Product Change Notification: PCN-22-136405

8P Mod jack , SE

Bulk Package to Tray Package

RESULTS:

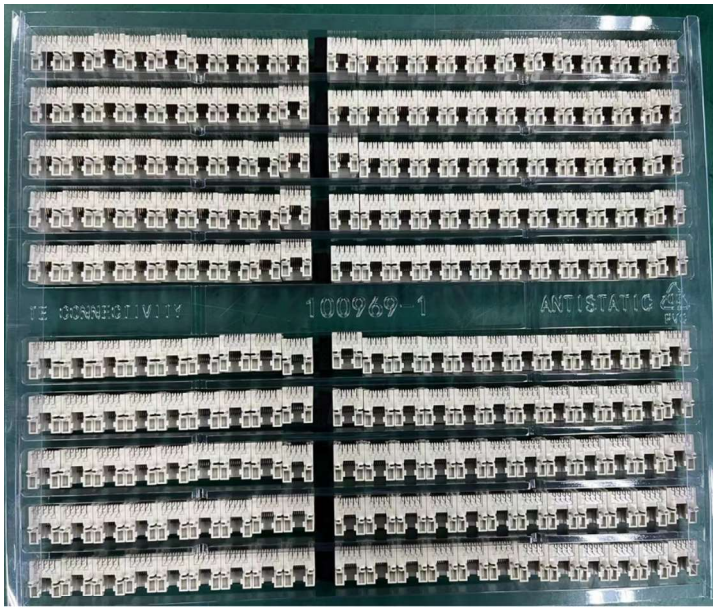
Pkg method: 210 pcs/bag x 6 =1260 Pcs/shipping box
 The detail packaging instruction is according to PS 107-107766 Rev A.
---Test result: There are no any products damaged and defect after drop test.
---The corner of shipping box impacted were distorted, but not damaged

0%, 0 pcs (NG) / 1260 pcs (OK) : 1 BOX

Change from bag to Soft Tray for MODULAR JACK SIDE ENTRY, 8 POS

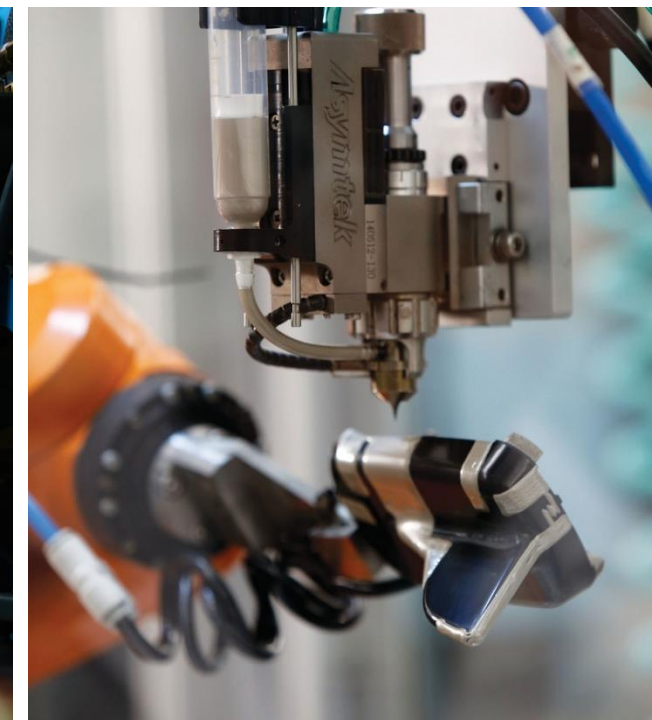
Bulk in bag packaging

Soft Tray packaging

Affected PNs : 3-215877-1 and 100190-2

Reason for change:- Connector Deformation may happen during transportation so changing to soft tray Package to avoid deformation.
